**Government of the District of Columbia
ADVISORY NEIGHBORHOOD COMMISSION 3-D**

RE: Z.C. Case No. 07-12 ---The George Washington University –
Mt. Vernon Campus Pelham Replacement Project
Post-Hearing Submission

**George Washington University
Pelham Hall Replacement Project
Z.C. Case No 07-12**

Response to GWU's July 30th Post-Hearing Submission

L104

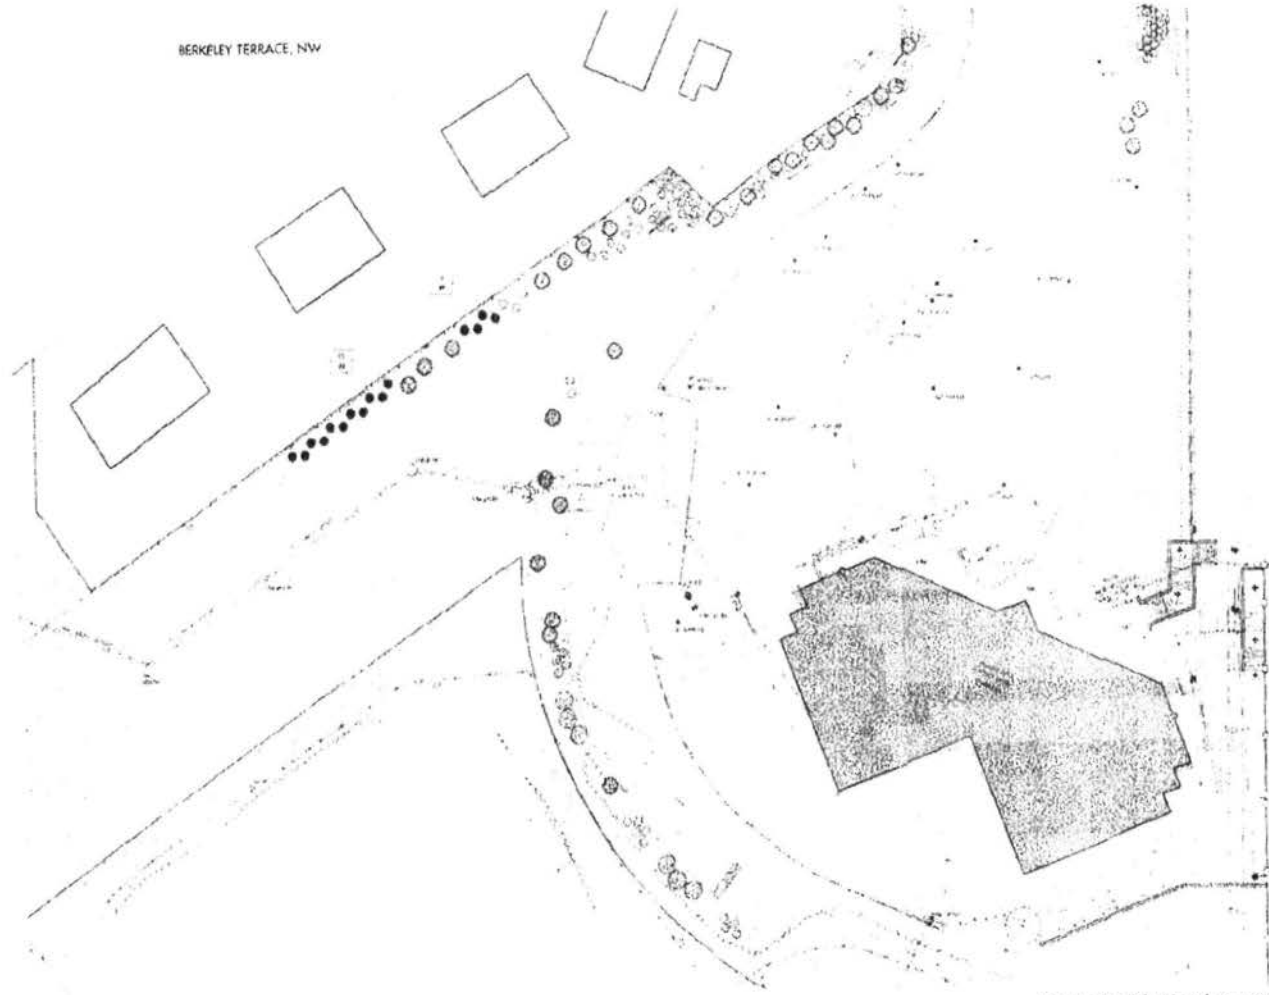
Your 2007 GW Enhanced Landscaping Plan (attachment C) includes the following:

- 15 new shrubs
- 66 plants remaining from the original 2000 Master Plan planting
 - 22 trees
 - 44 shrubs
- Total of 81 plants

Some simple math shows that 20 trees have died or been removed between 2000 and 2007. Therefore, in order to restore the original GW 2000 "Buffer Plan", at least 20 new trees should be added to the proposed new shrubs shown on the Enhanced Landscape Plan diagram for Berkeley Terrace. We understand this landscape plan is separate from the additional landscaping buffer that will be provided as part of the new Pelham Hall zoning application.

As you know, our concern is for year-round screening. Unfortunately, some of the 2000 plantings have been inadequate because they were not the appropriate type for this shaded area, have died or are deciduous. We trust that your new landscape architect (Stephenson & Good) will learn from the lessons of the old one (Clough, Harbour & Associates) and specify the appropriate materials.
